ADDENDUM NO. 4

Reference: UVU Student Life Center & Parking Structure
Orem, Utah
DFCM Project No. 10289790

ADDENDUM NO. 3

The original specifications and drawings, dated April 27, 2012 for the project referenced above are amended in this Addendum No. 3, dated May 09, 2012.

AS-103-01

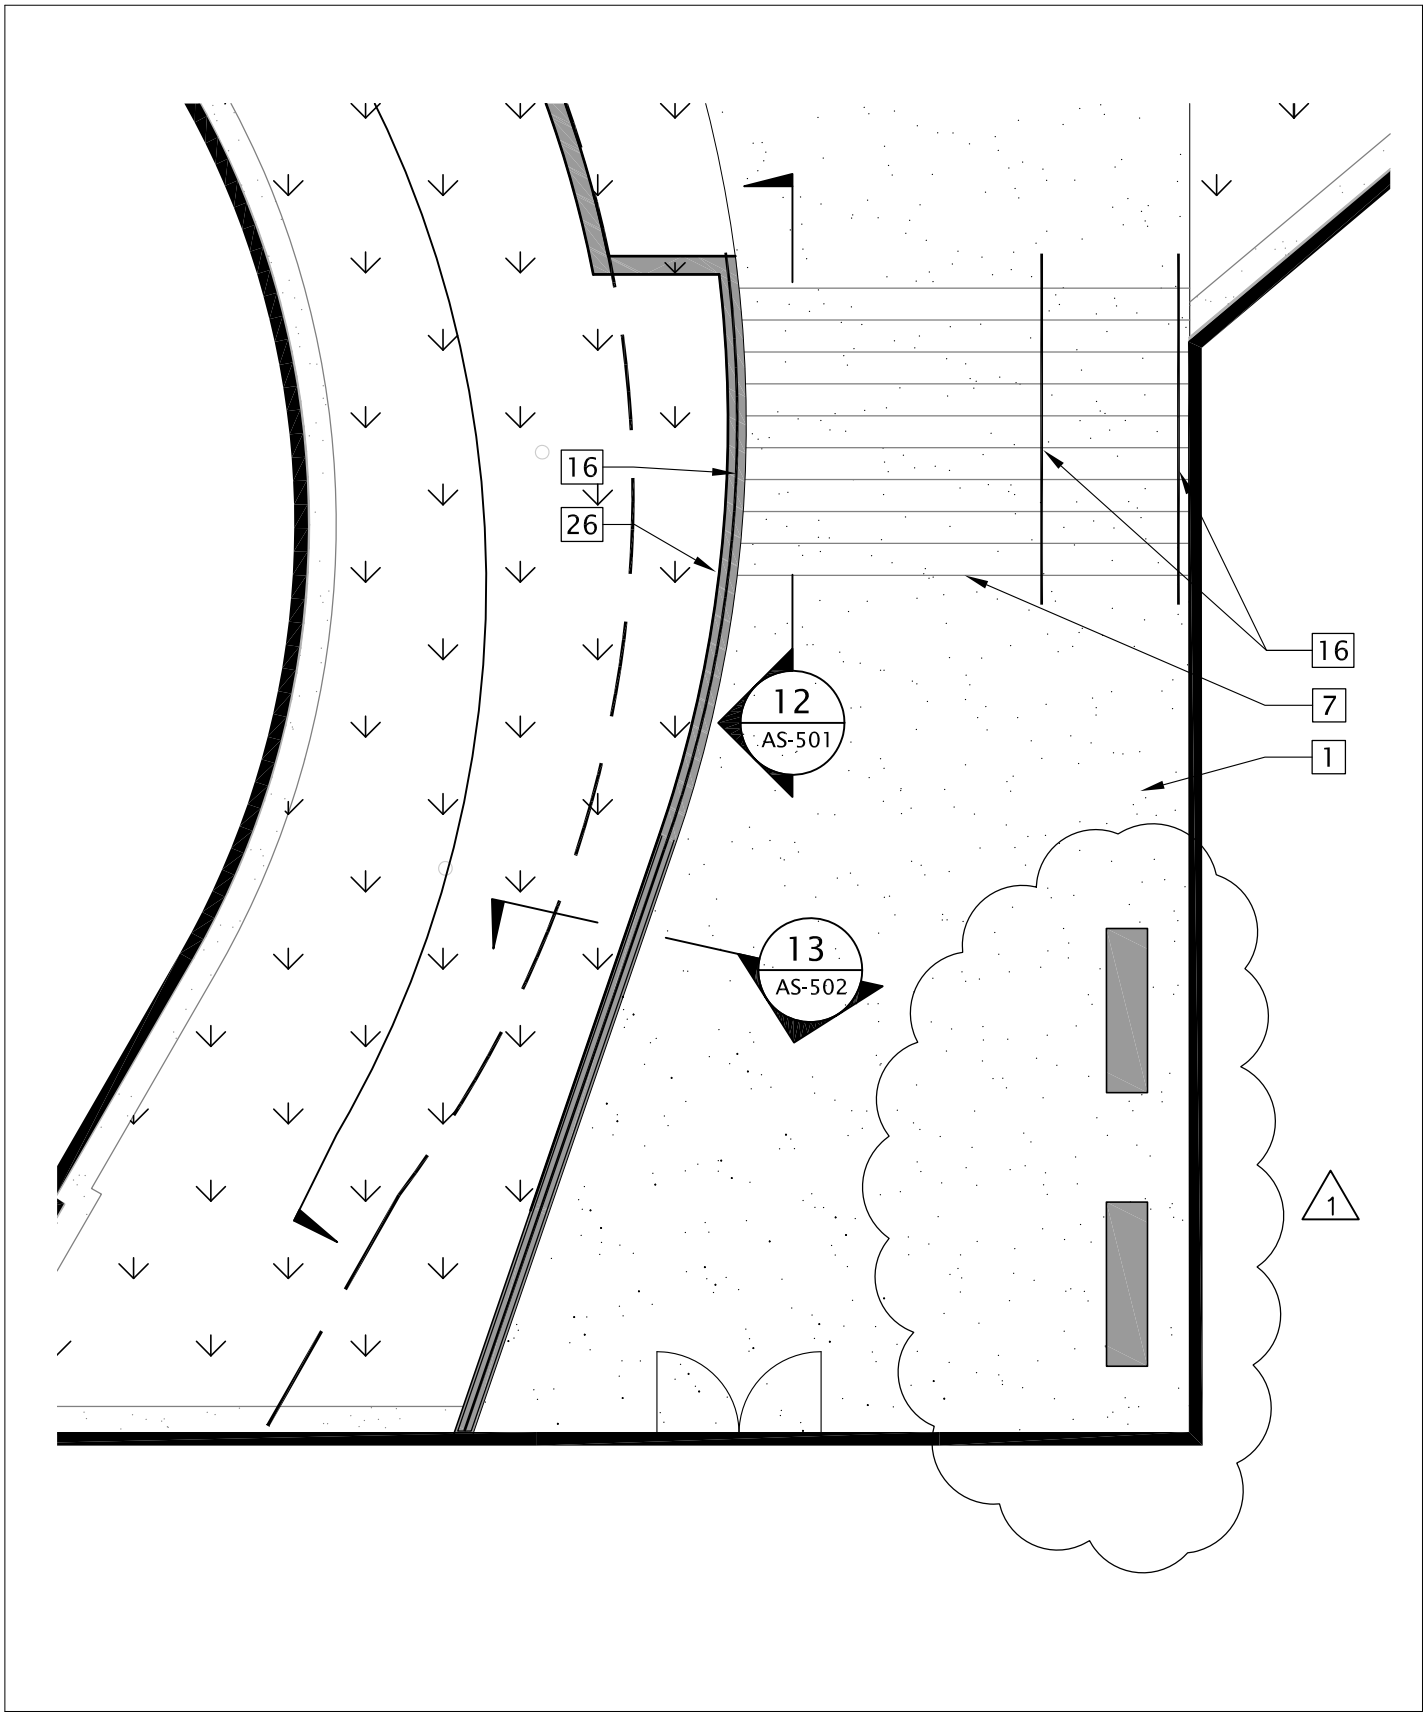
3-14	AS-103	The colored concrete has been removed from the north entrance and the concrete benches in this area are now shown in the enlarged plan.
3-15	AE-153	In the equipment schedule, add “EQ-2G” in the “TAG” column of Gym Equipment – Volleyball Equipment (MAC GYM). Added “Gym Equipment – Clock Wall Mounted” in three court gym and MAC gym. Added “Misc. Equipment – Ice Maker” to First Aid Room 301-A
3-16	AE-605	Changes have been made to the Glazing Legend clarifying differences between the IG-1 and IG-1A glazing types. See attachment.
3-17	AE-606	Revised door number 122N to read 122N-1 Door information added to doors 311A-4 through 311A-17 – See attachment The location of door 204-1 in the schedule was updated to match its level A door hardware set was assigned to door 101A-2 A door hardware set was assigned to door 400M-1 A door hardware set was assigned to door 211L-1 Legend notation added – “GLS-Glass” under Door Material.

1 FIRE PROTECTION ELEVATION - EAST

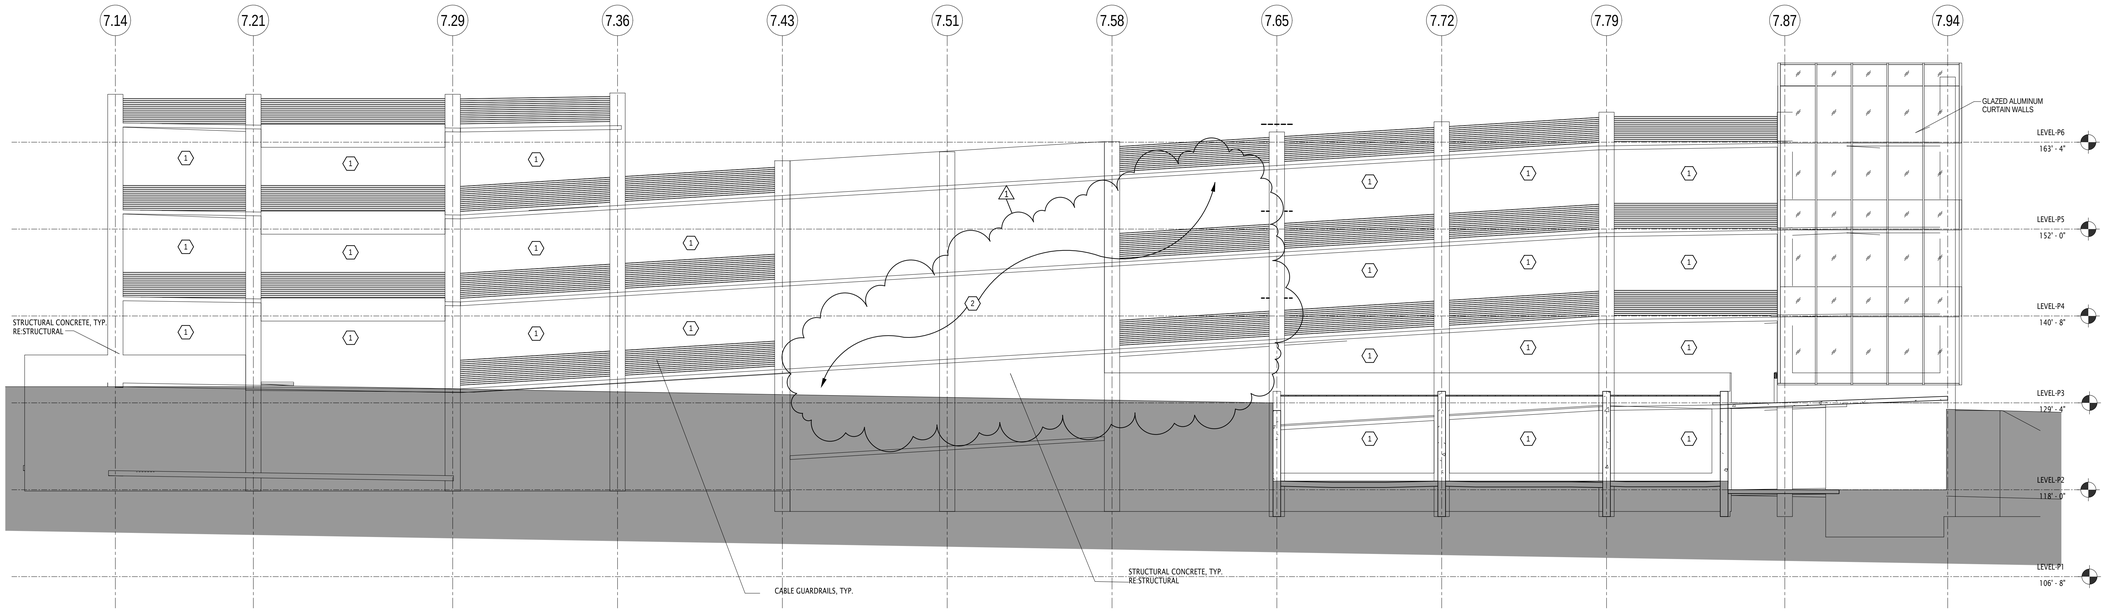
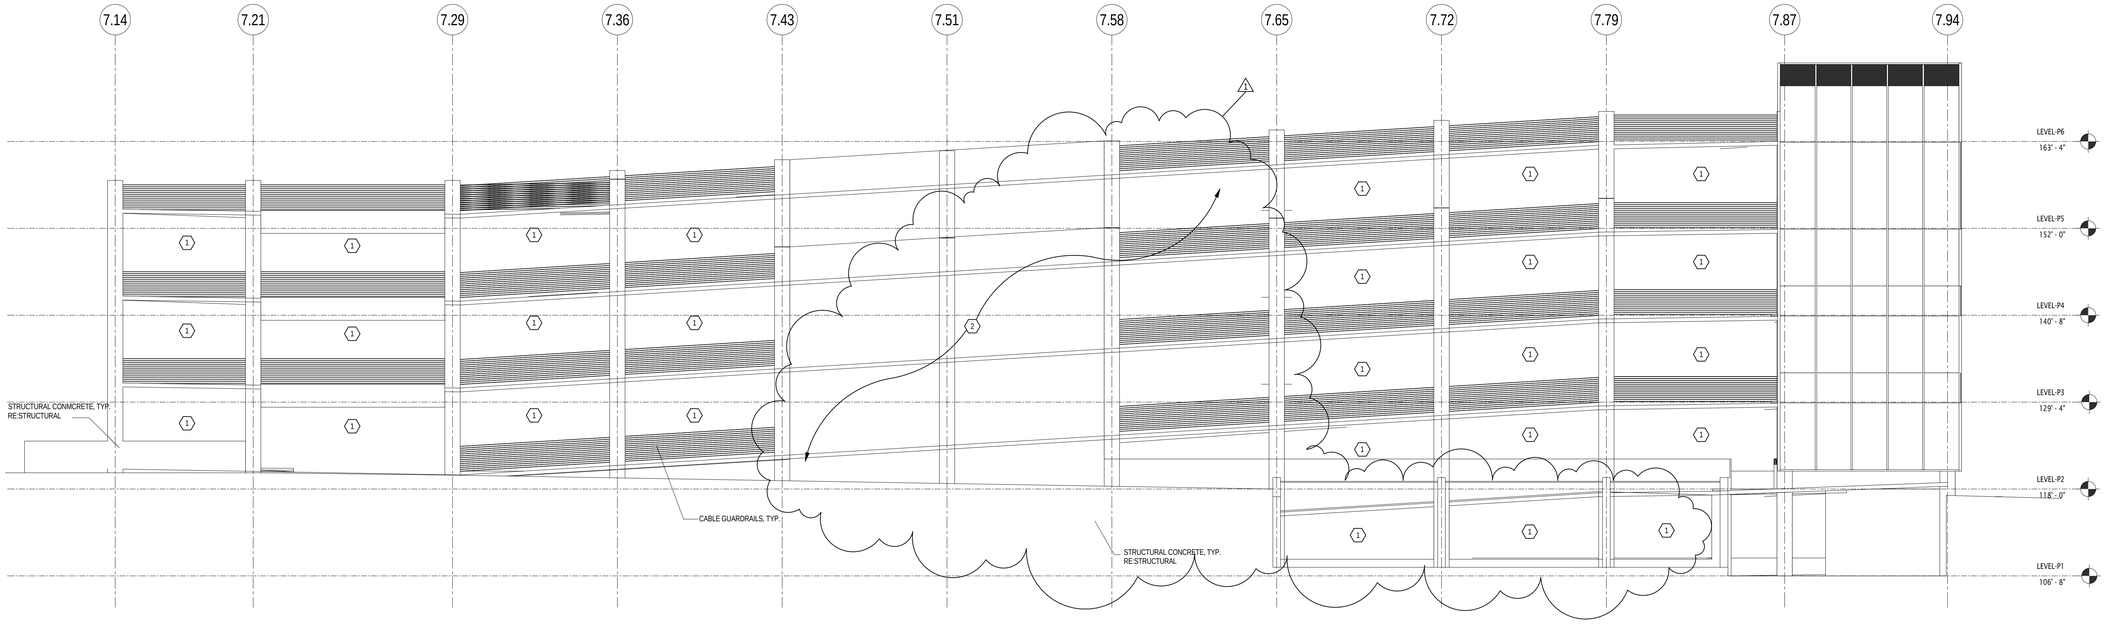
Item No.	Add, Delete or Clarify	Specification Section or Drawing No.	Reference / Description:
10	Clarify	FF3.01	-See revised east garage wall elevation that shows revised shear wall area and designations of wall openings that require opening protection.
11	Add/Clarify	230900	-See revisions to control sequences and the air handler sequence table. -Fire pump is being added as part of bid alternate for additional parking garage floor. Monitor points on fire pump system identified in revised sequence. This is only part of the bid alternate, not part of the base-bid. -See sequence changes at end of this narrative.
12	Add	211000 FF3.01	-Add a fire pump to the bid alternate for the additional floor of parking garage. -See revised shear wall and openings on sheet FF3.01.
13	Clarify	MH051	-Clarify Keyed Note 1, 2, and 3.
14	Clarify	MH1.13A	-Clarify UH-4 and UH-5 equipment tag. -Clarify floor grille equipment tag.
